REQUEST FOR INVITATION TO BID #2026-02
CAMPUS ELECTRICAL DISTRIBUTION
ADDENDUM III
March 4, 2026

1. **Exhibit A – Plans (v.02162026)** shall be amended to include the attached Revised C1.1 – C1.4.

ELECTRICAL PAD PROPOSED SITE PLAN
OREGON INSTITUTE OF TECHNOLOGY
3201 CAMPUS DR.,
KLAMATH FALLS, OREGON 97601

4 EAST WALL SECTION
C1.2 1" = 5'

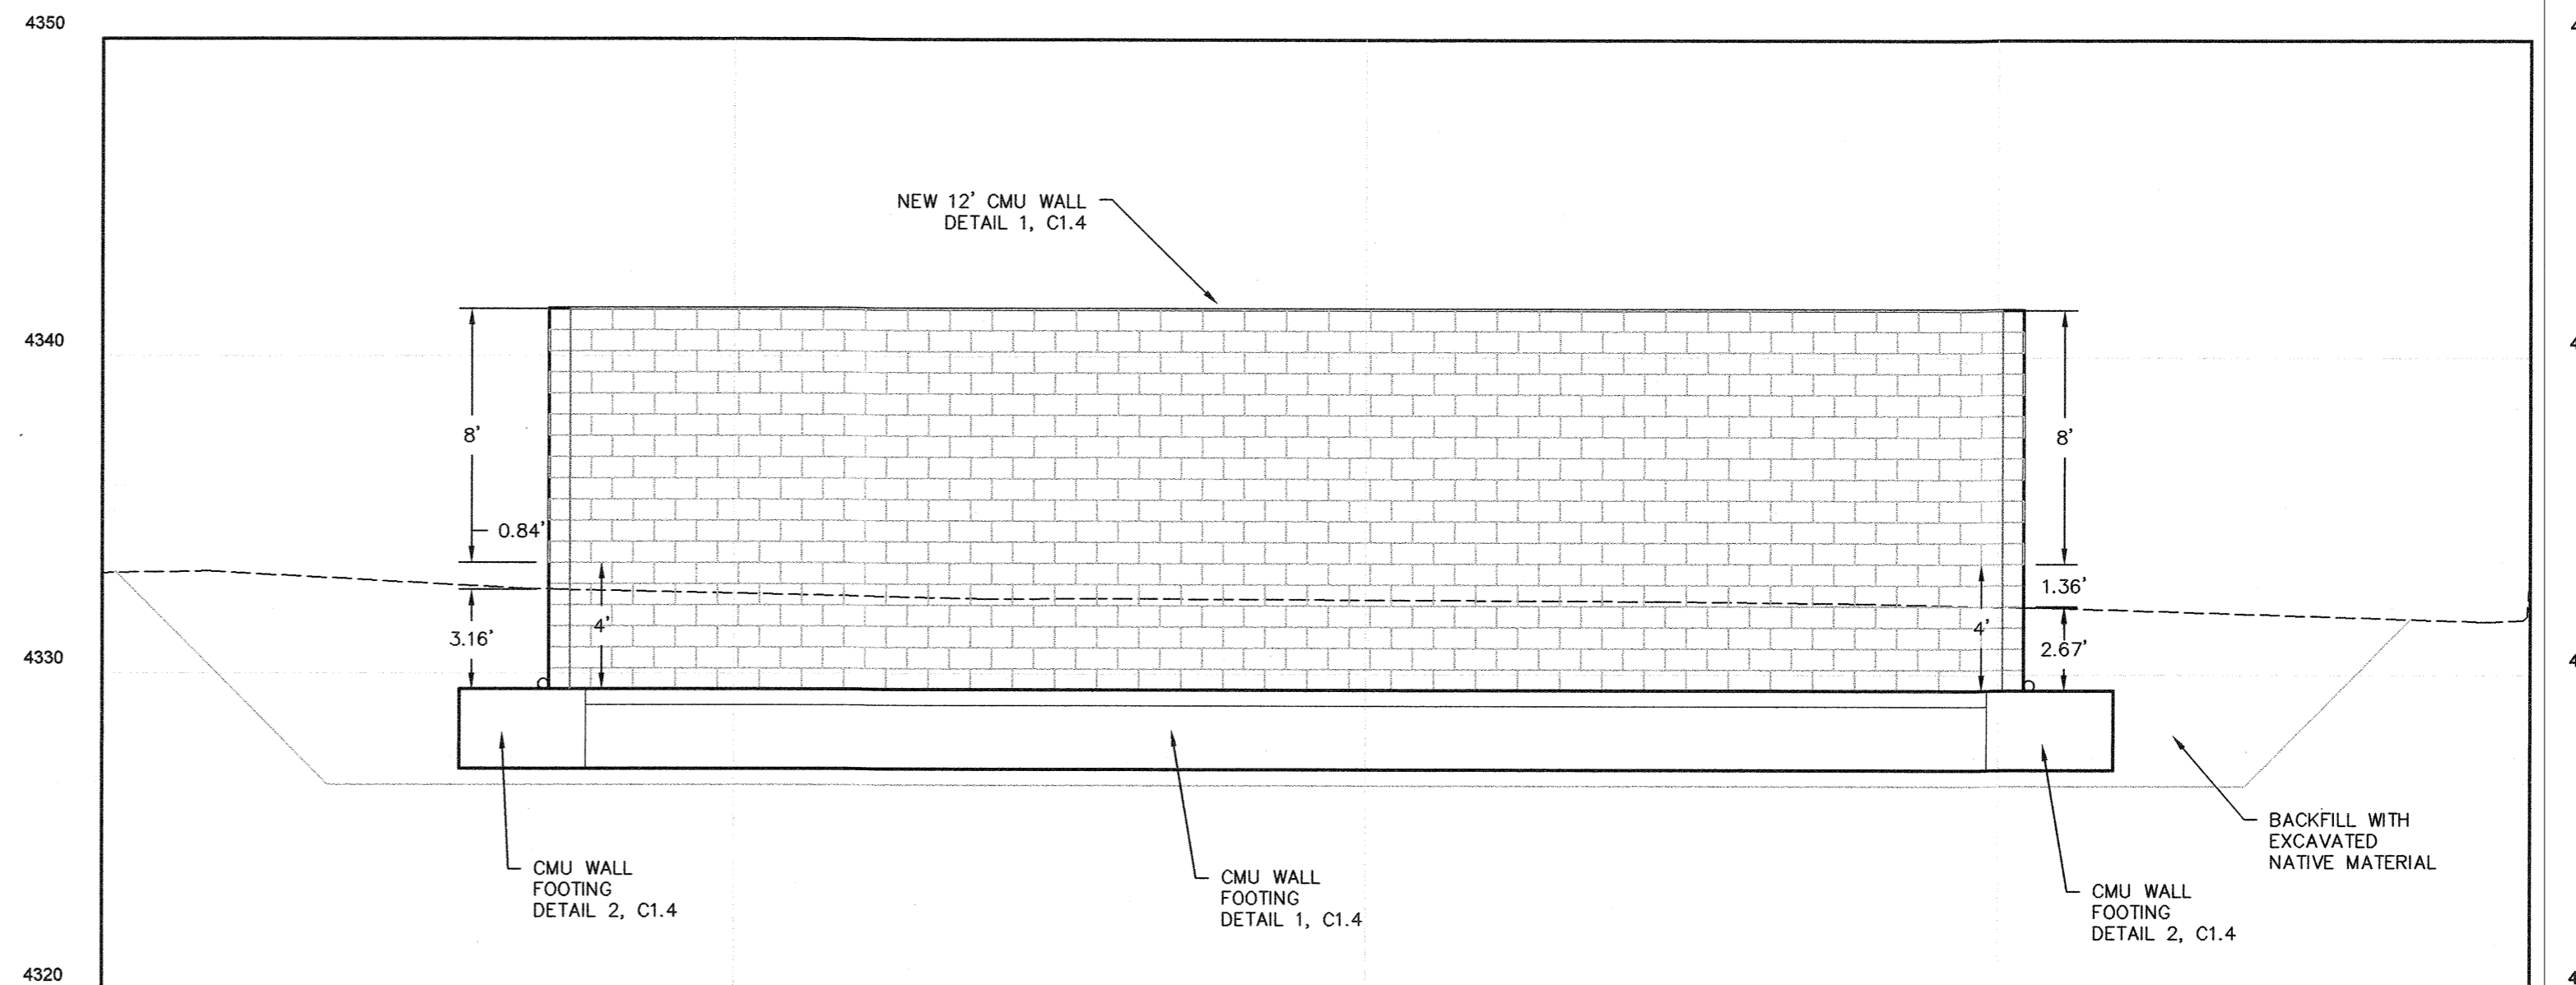
DATE	REVISION DESCRIPTION	BY
8/2/25	FIX TEXT	R.C.
3/1/26	LOWER CMU WALL, REMOVE COVER	R.C.

ELECTRICAL PAD PLAN VIEWS
OREGON INSTITUTE OF TECHNOLOGY
3201 CAMPUS DR,
KLAMATH FALLS, OREGON 97601

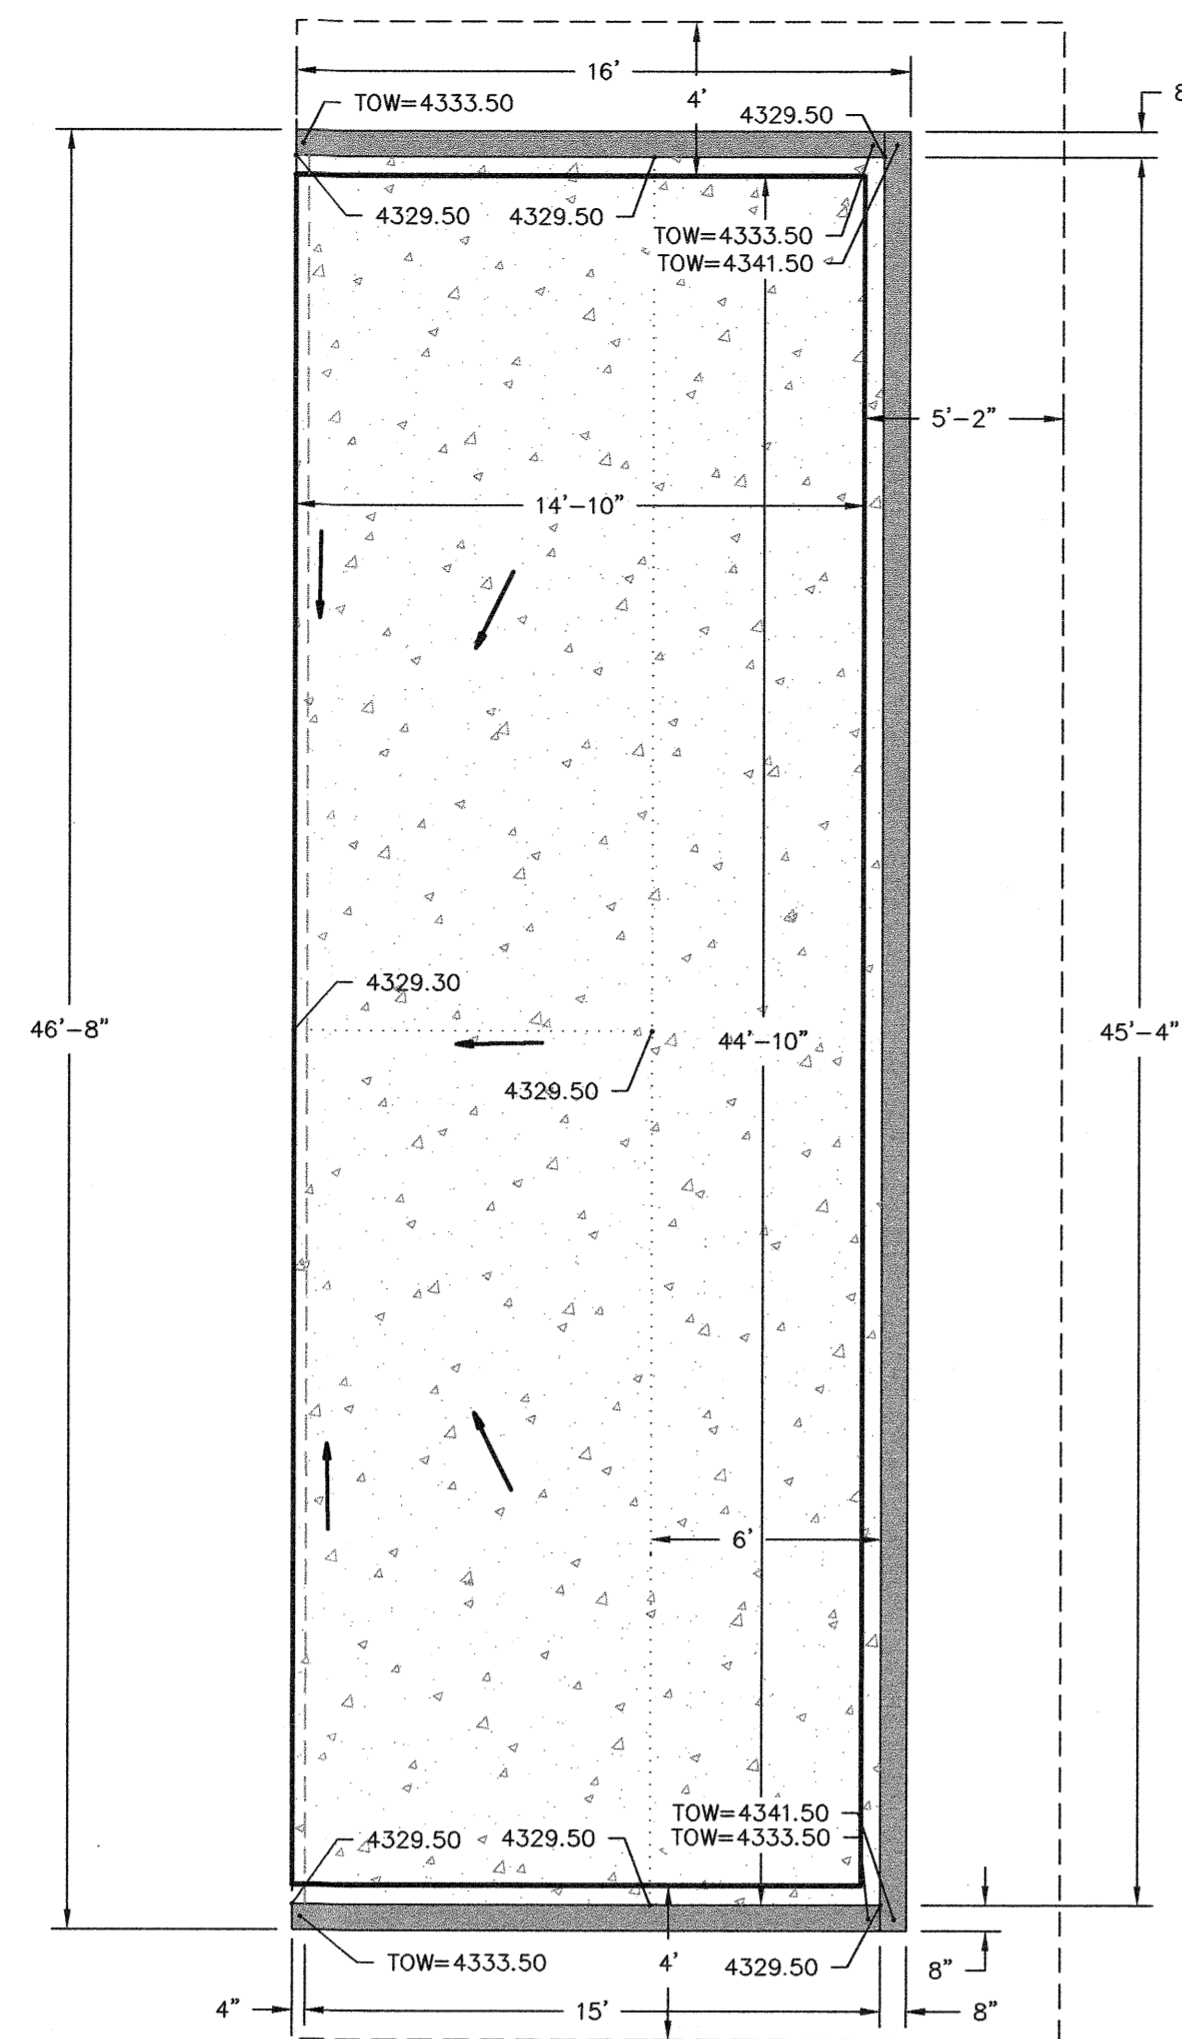
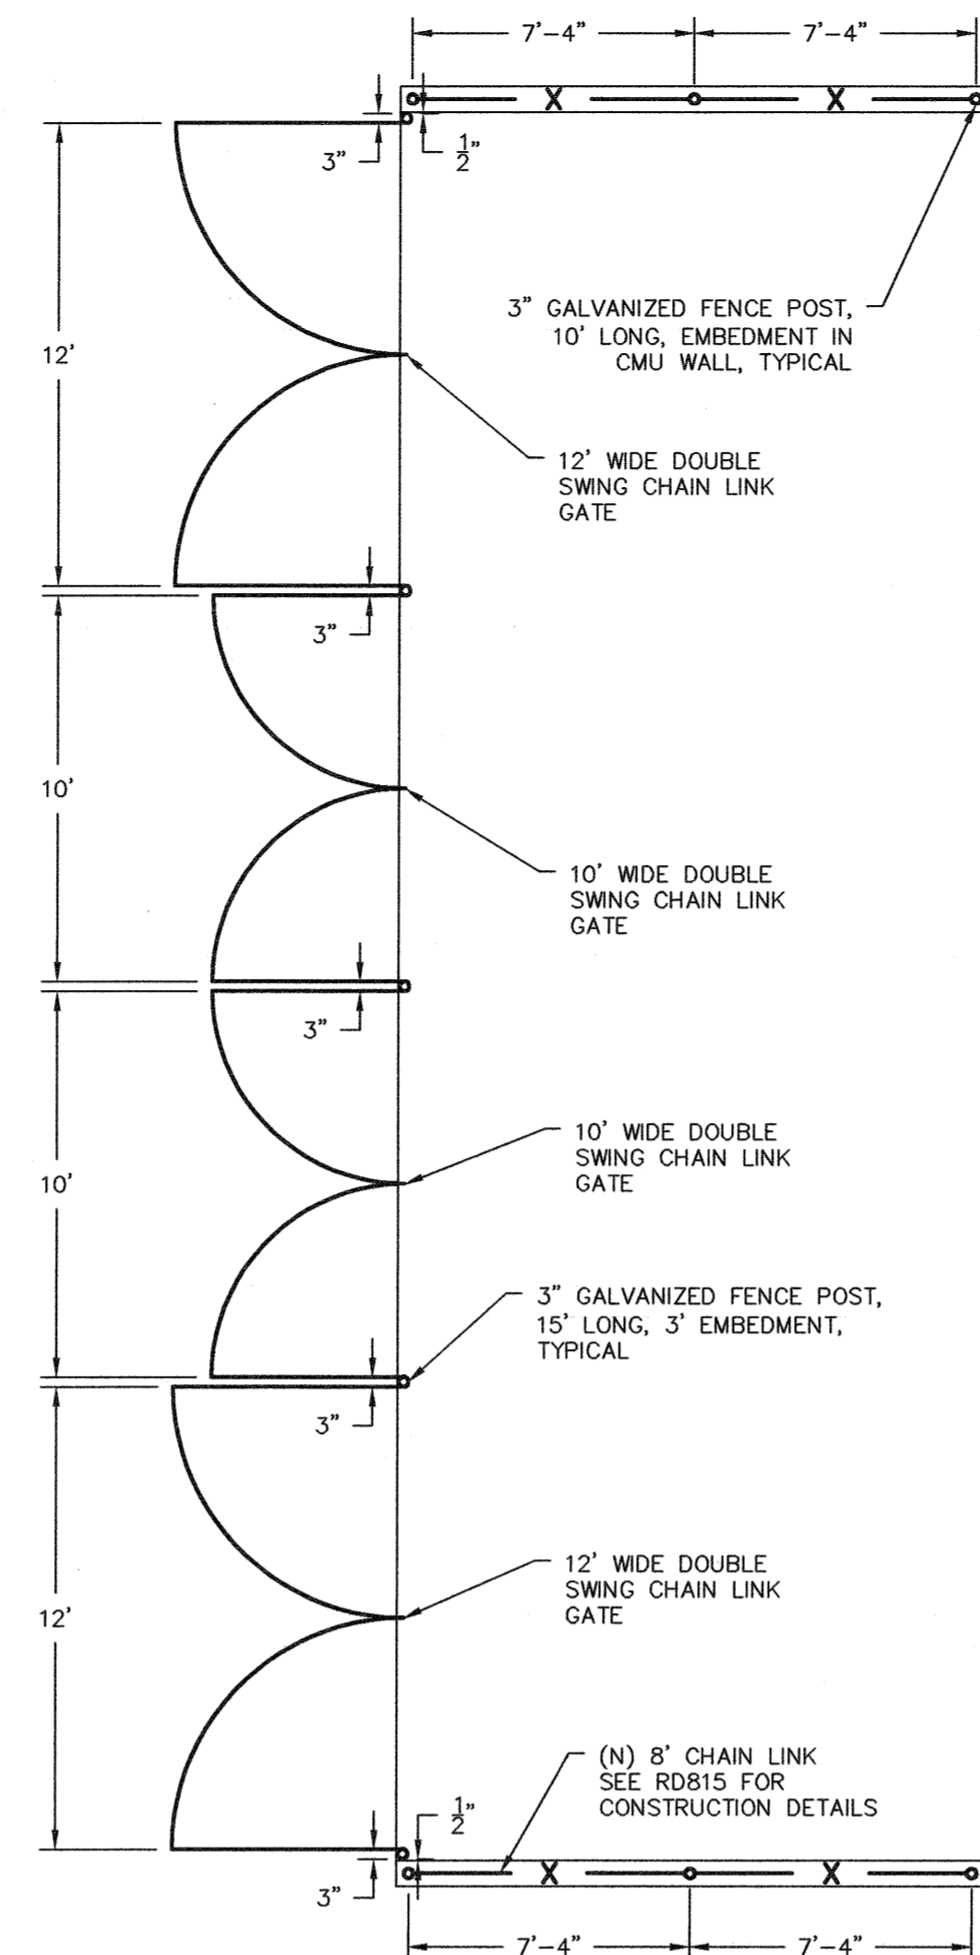
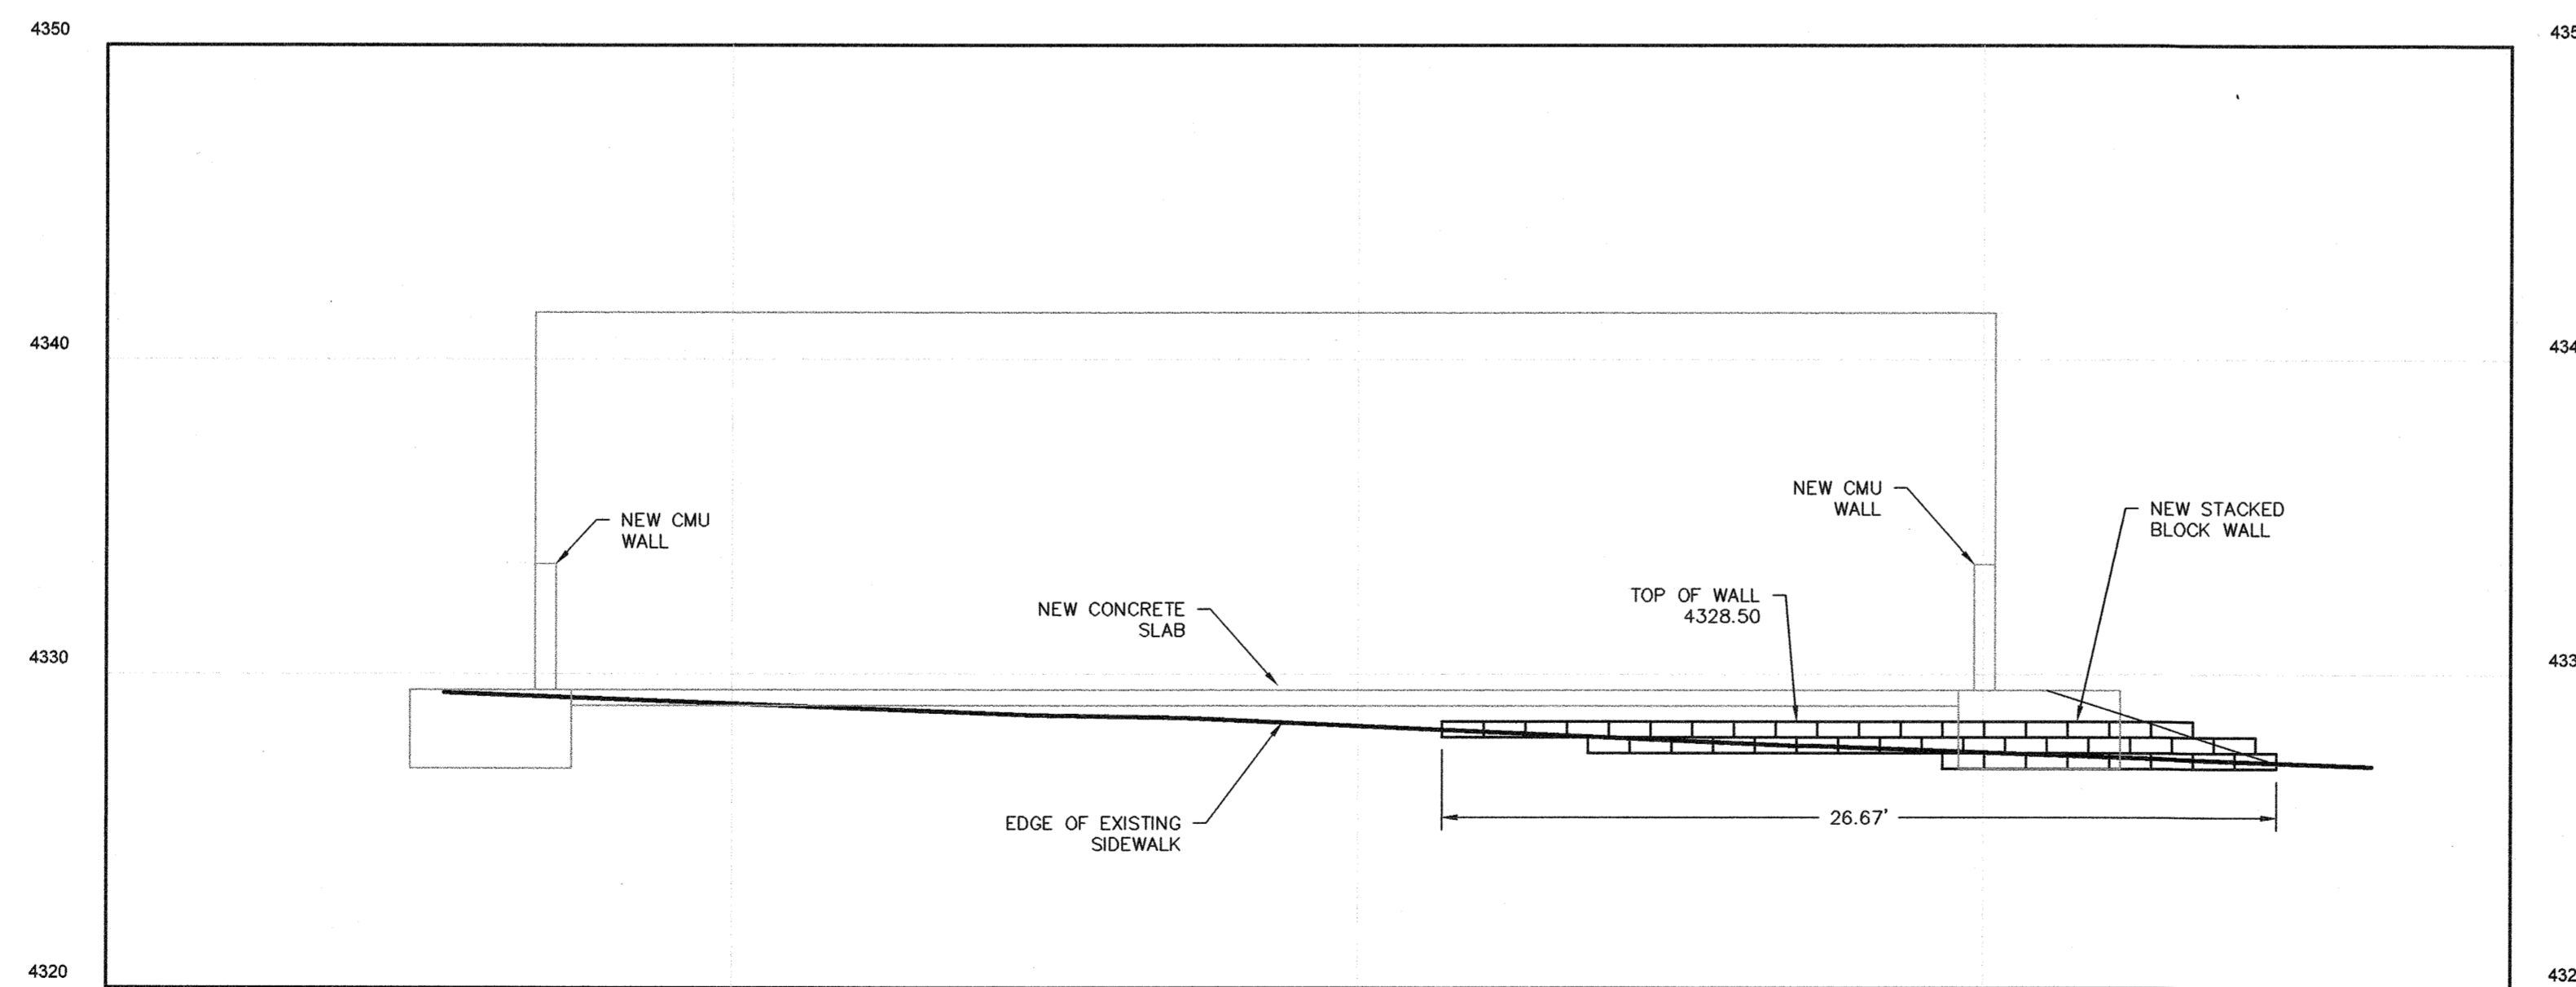
DATE	REVISION DESCRIPTION	BY	R.C.
3/7/26	LOWER CMU WALL REMOVE COVER
